Millstone Nuclear Power Station, Unit No. 3
Seismic Qualification Review Team (SQRT) and Pump and Valve
Operability Review Team (PVORT) Audits

Responses to SQRT Audit Questions

NRC SQRT AUDIT QUESTIONS

FIGURE 1

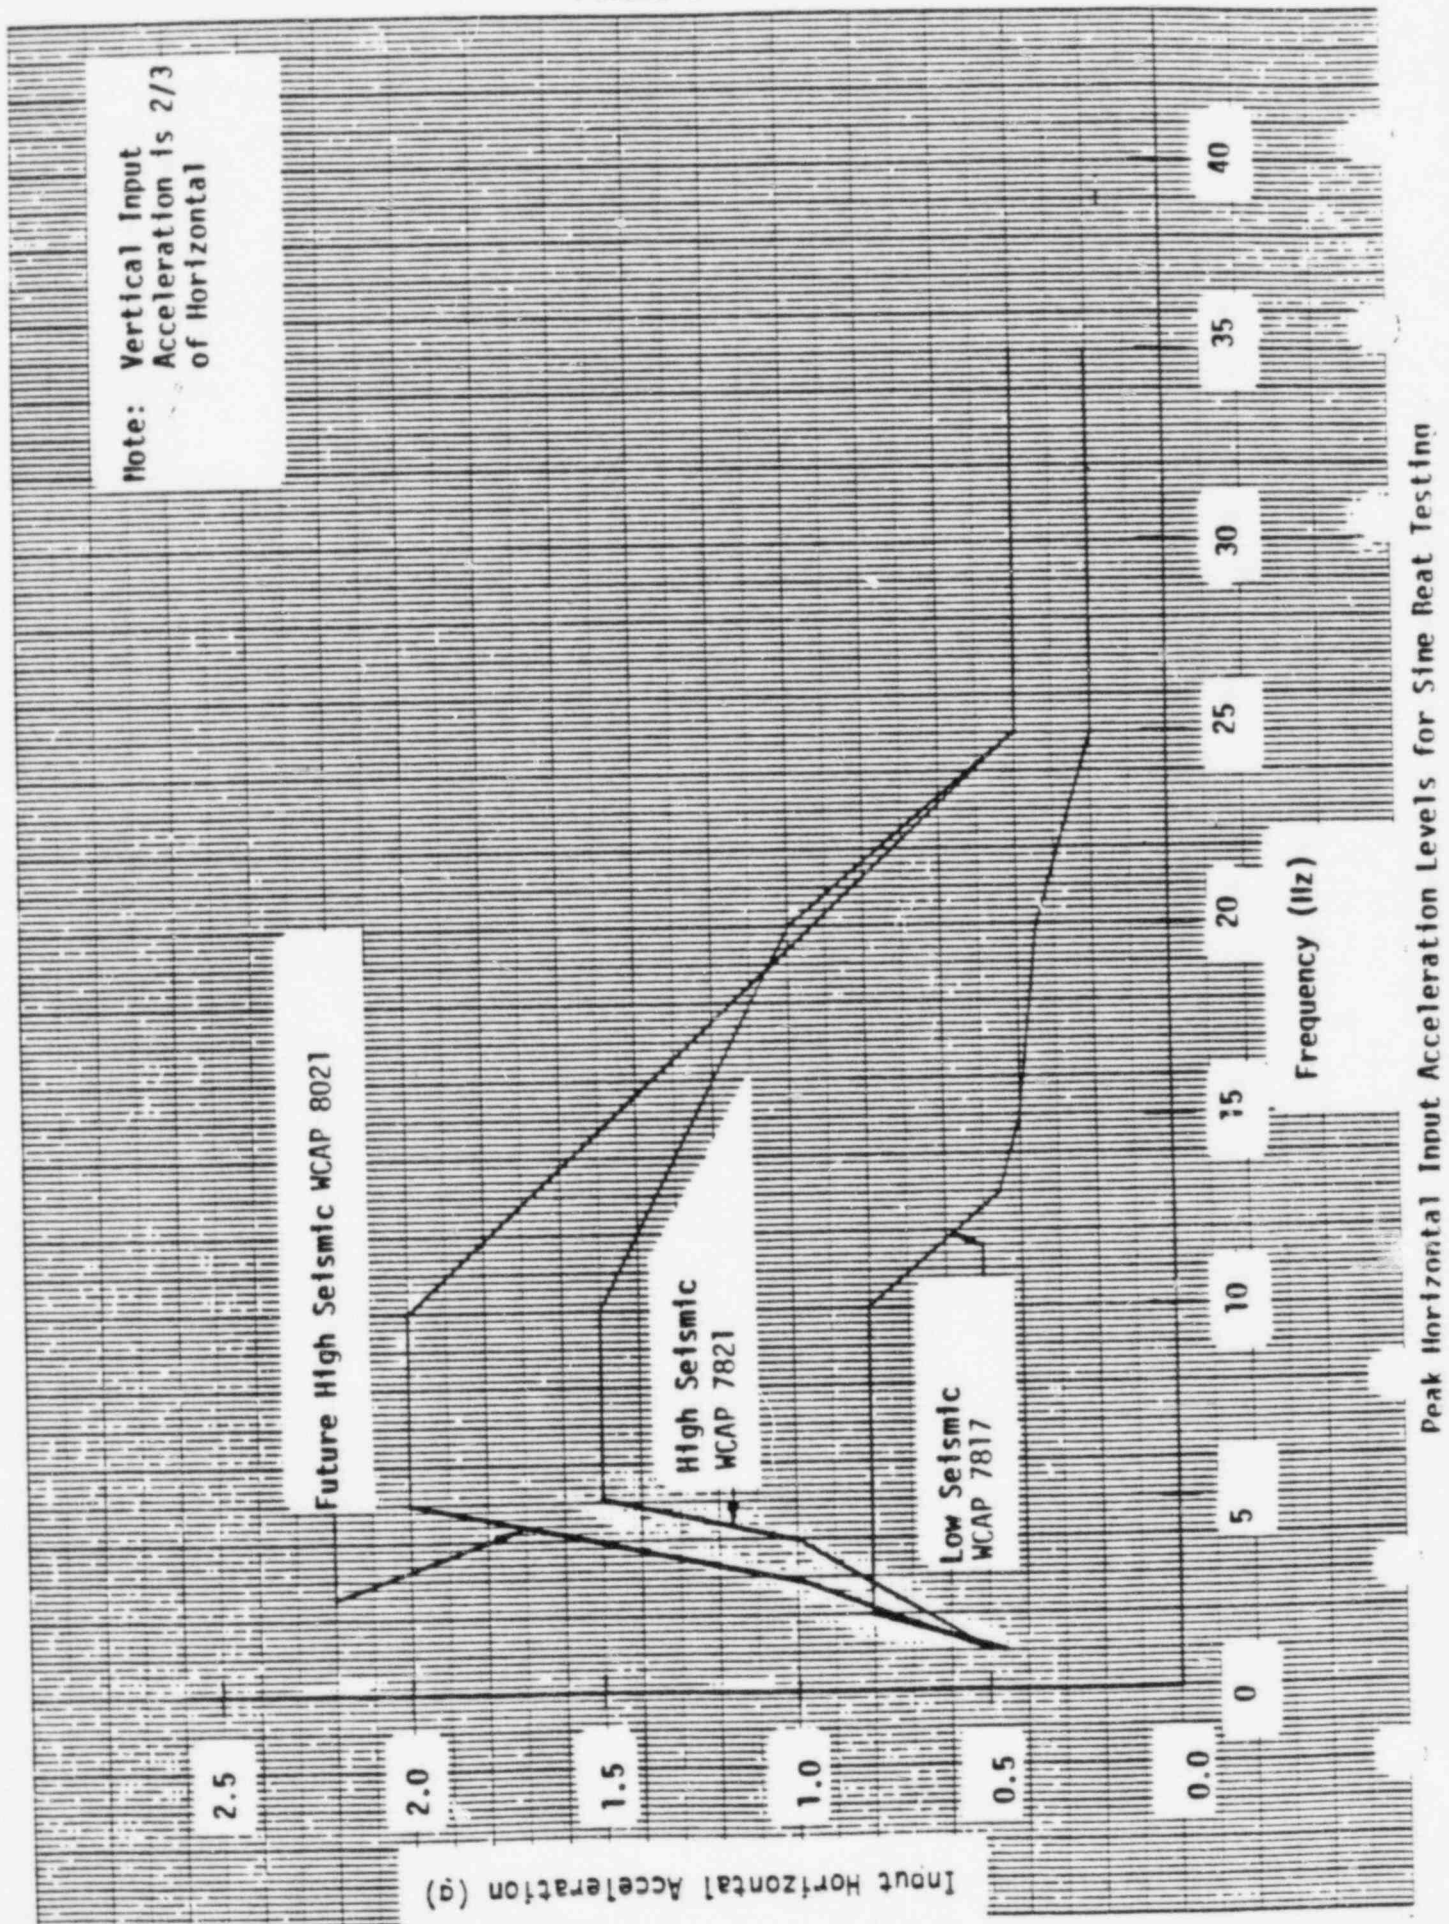
Westinghouse will provide a Millstone 3 specific demonstration that the tests performed for the NIS console provided the equivalent of 5 OBEs and 1 SSE.

The NIS console was qualified for Millstone 3 application to the high seismic level as shown in Figure 1. The predominant natural frequencies of the NIS console were found at 5.0 to 7.7 Hz in the horizontal directions, while the NIS was found to be rigid (resonances above 33 Hz) in the vertical direction. The NIS console is mounted in the Millstone 3 control building at elevation 47 ft. The Millstone 3 response spectra associated with this mounting location are provided in Figures 2 through 7.
